**ADDENDUM**  
**ENVIRONMENTAL IMPACT REPORT**

**LIVERMORE-AMADOR VALLEY QUARRY**  
**RECLAMATION SPECIFIC PLAN**

**Alameda County Planning Department**  
**August 15, 1980**

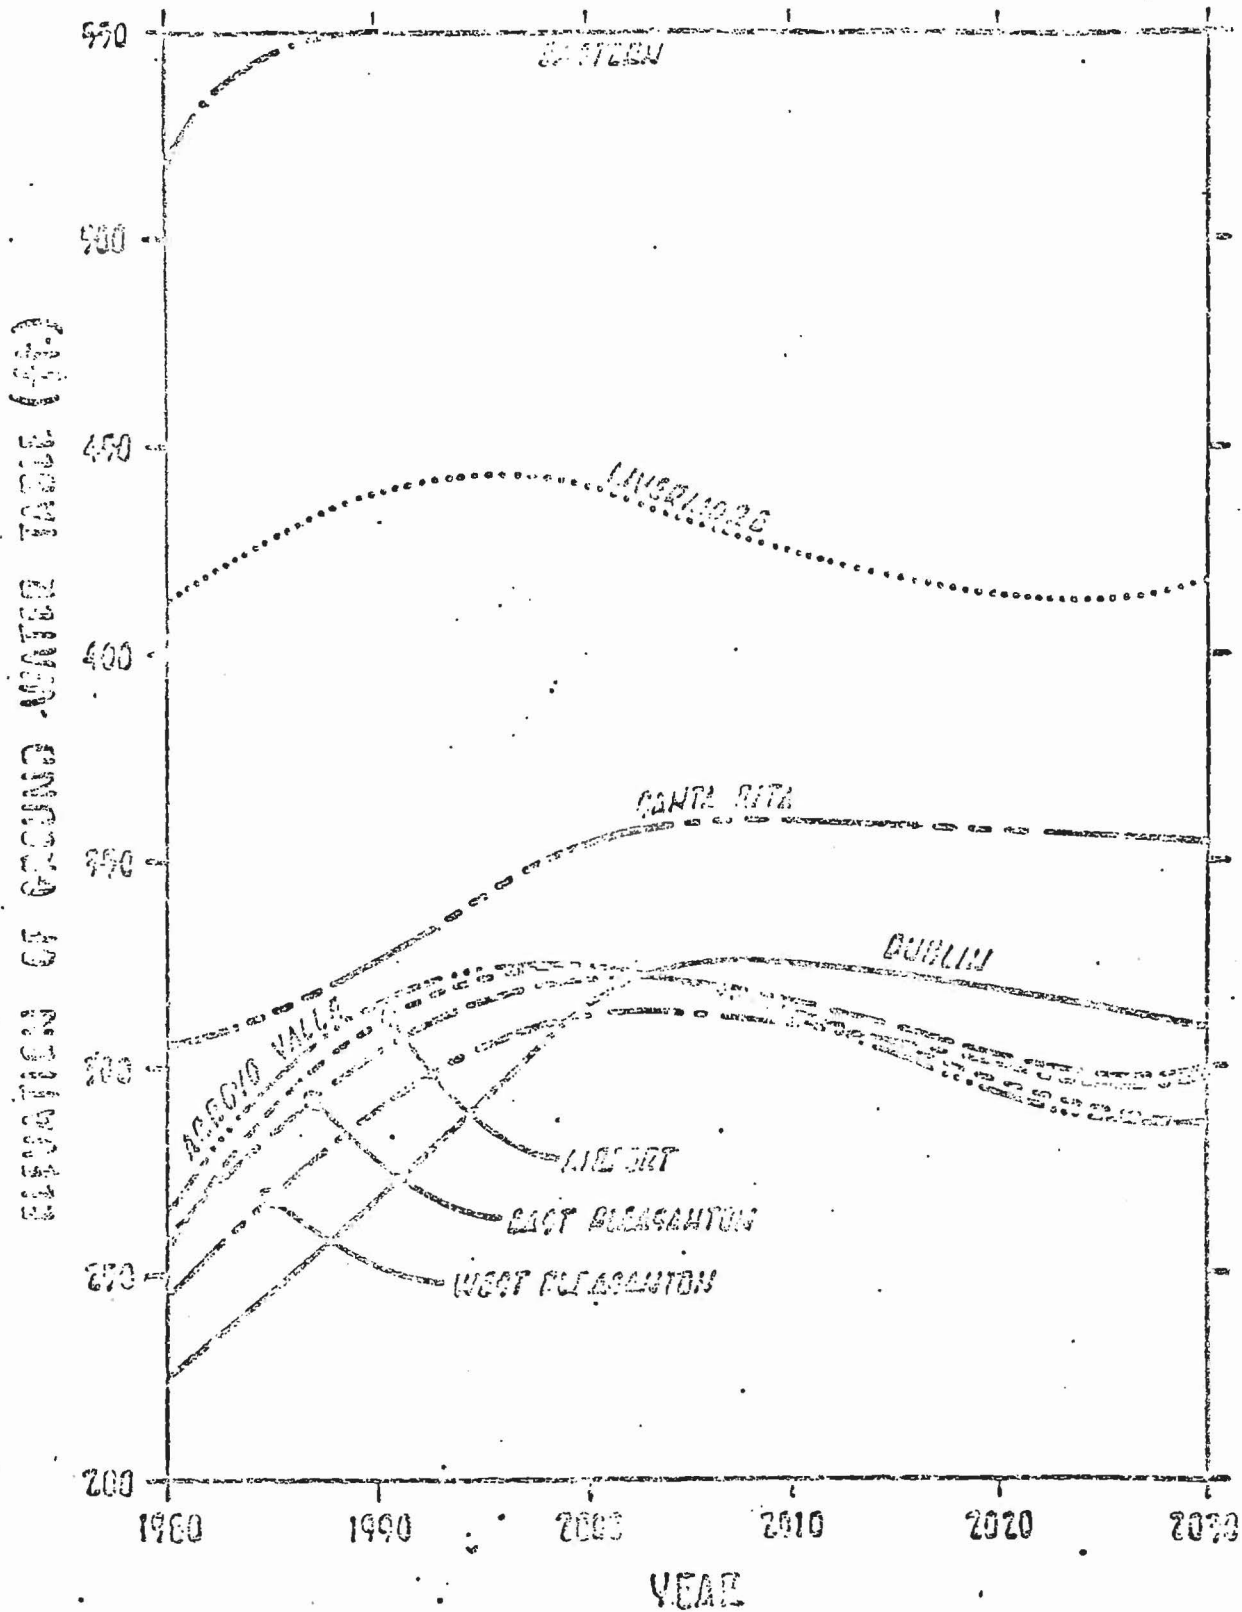
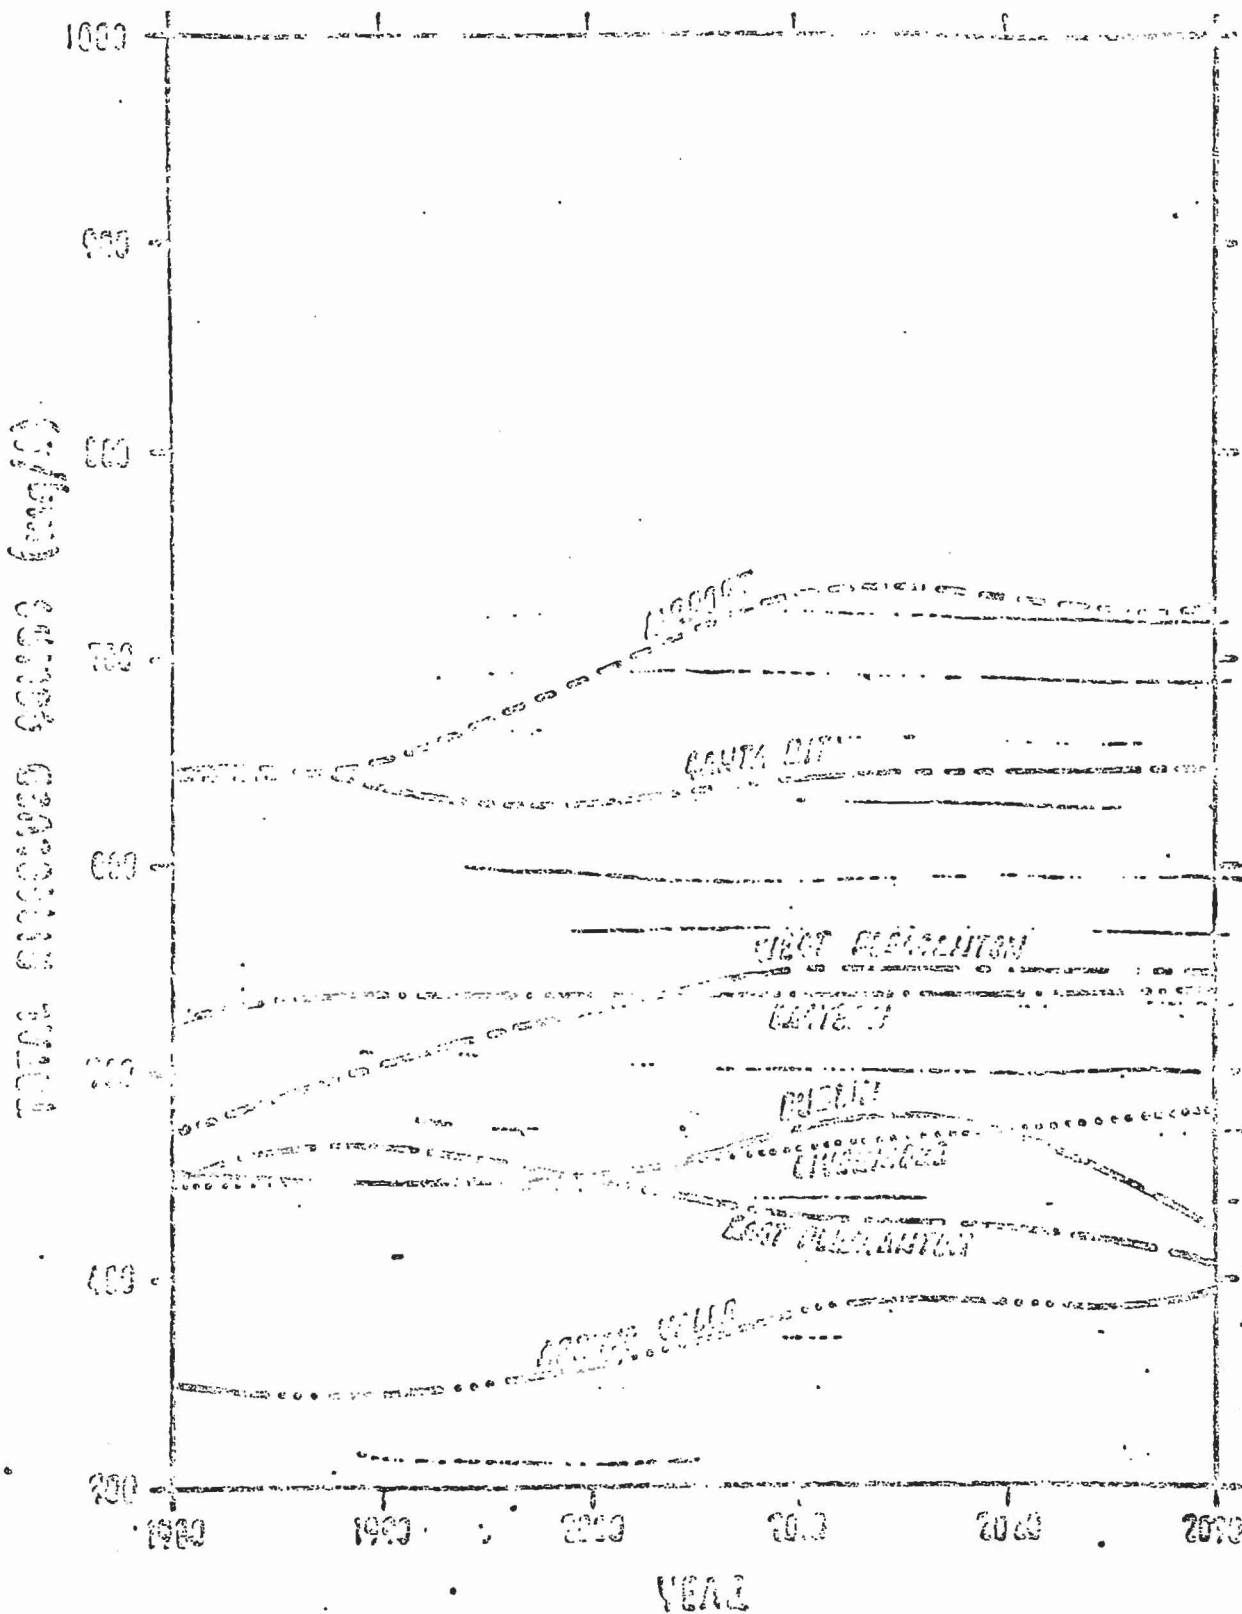
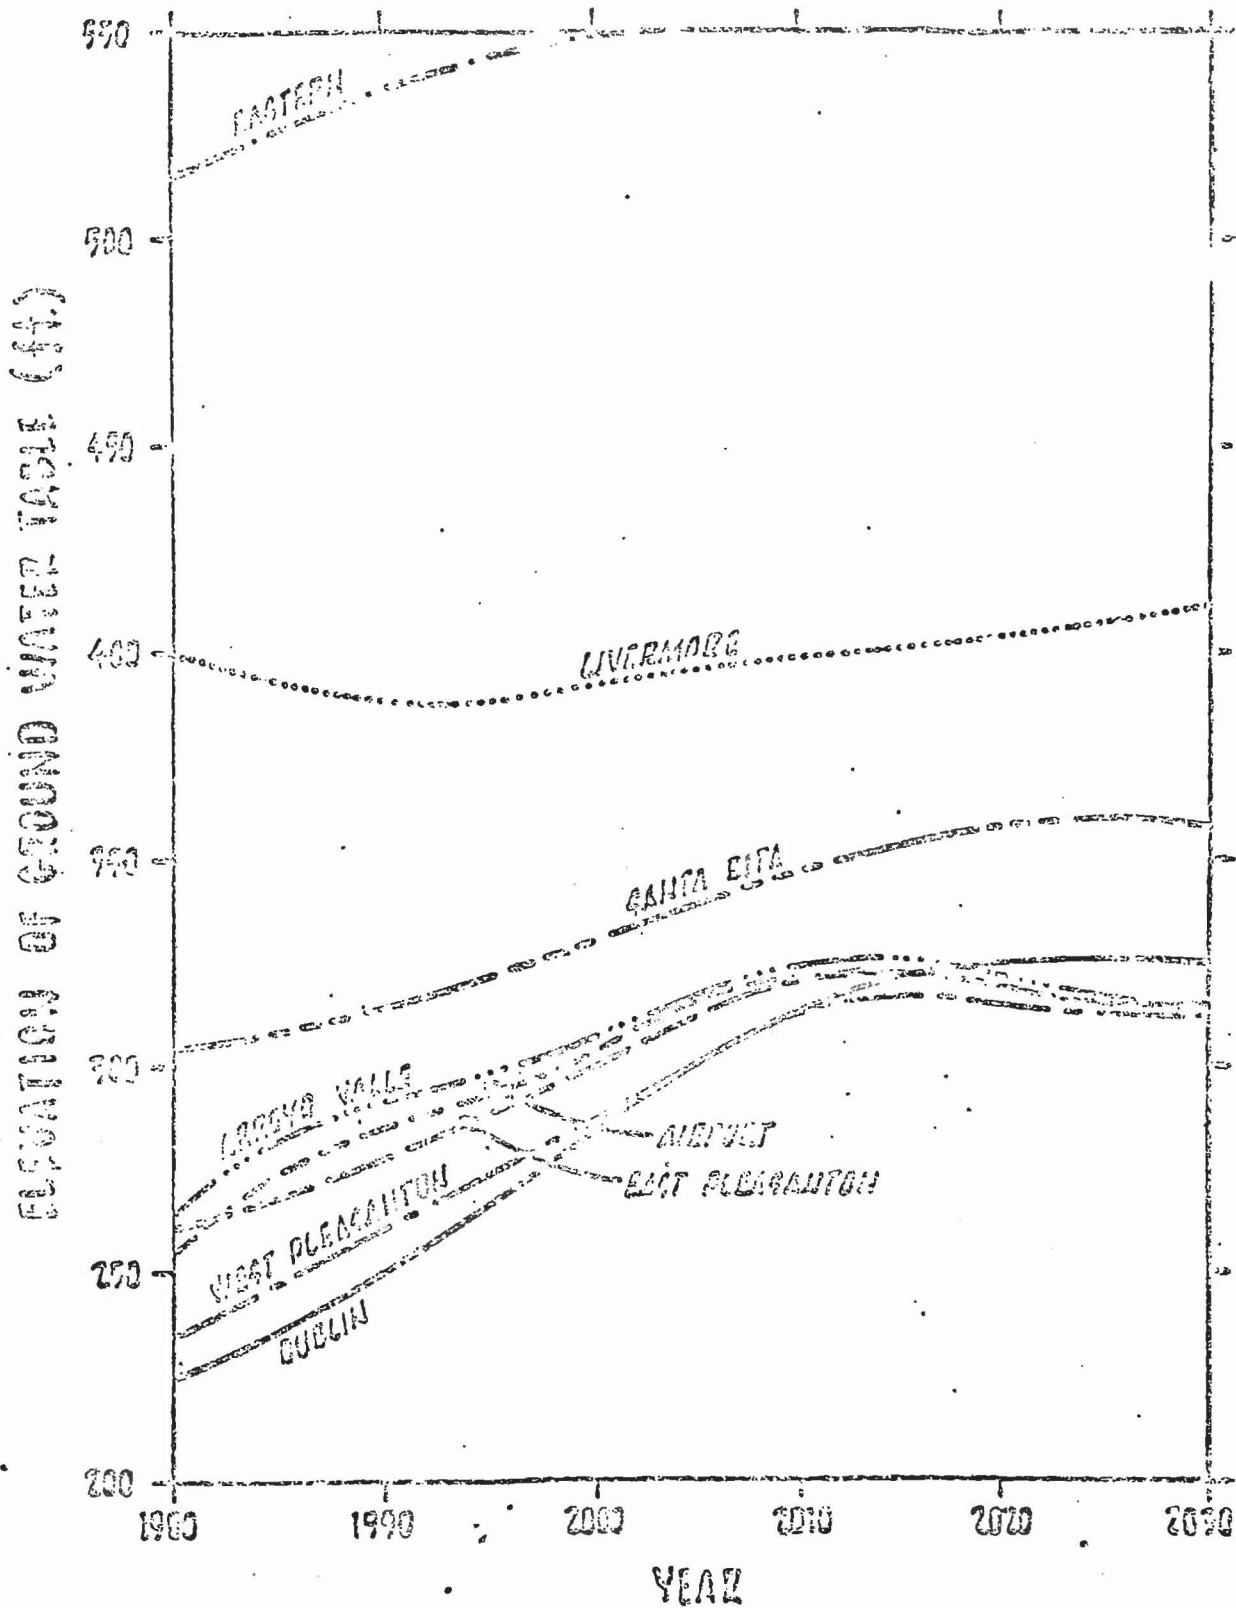
Since publication of the Draft EIR, results of a study of future water quality under various quarry alternatives has been released by CH2M Hill, consultants to Livermore-Amador Valley Water Management Agency. Results are discussed in Subsection G of Section I (Comments on response of Regional Water Quality Control Board). It must be emphasized that the study is based on a model and certain assumptions which are imperfect. Future studies will still be necessary to refine the model and assumptions so that water quality can be predicted with more confidence. Maintaining good water quality in the lakes will depend on passing through and using sufficient water to prevent salt buildup. Periodic flushing with flood flows may be required. Predictions of salt concentrations depend upon many factors, including inflow, outflow, water depth, water volume, surface area, depth-volume-area ratios, mixing ratios, thermocline location, temperature change, equilibrium points, location of inflow and outflow points, and quality of inflow water. The studies of different management strategies (routing studies and studies of the chain of lakes in context of the groundwater basin) are important in determining water quality impacts.

FIGURE 9-2

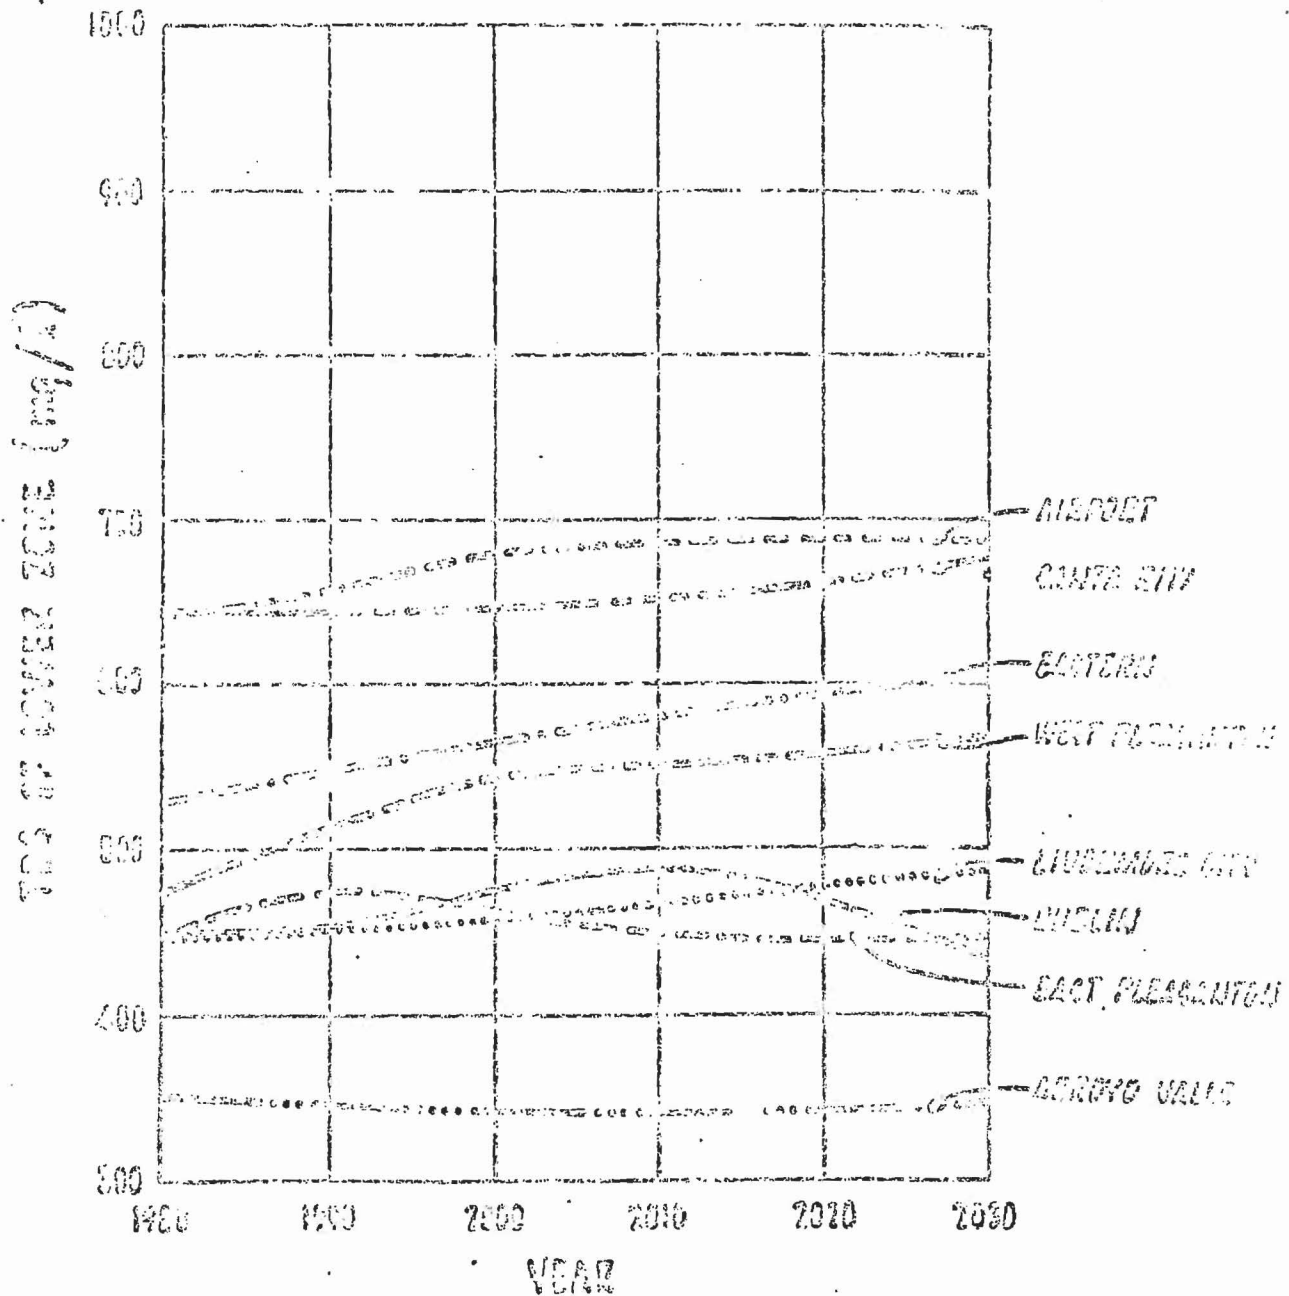
- a. We find the alternative plan is substantially improved over the earlier plan. Based upon LAVWMA/CH2M-Hill's groundwater model analysis of May 12, it appears that the alternative plan has reduced water quality impacts to a level comparable to a fully mitigated quarry plan. (Ref: May 12 meeting and LAVWMA Phase I report, Figure 9-2).
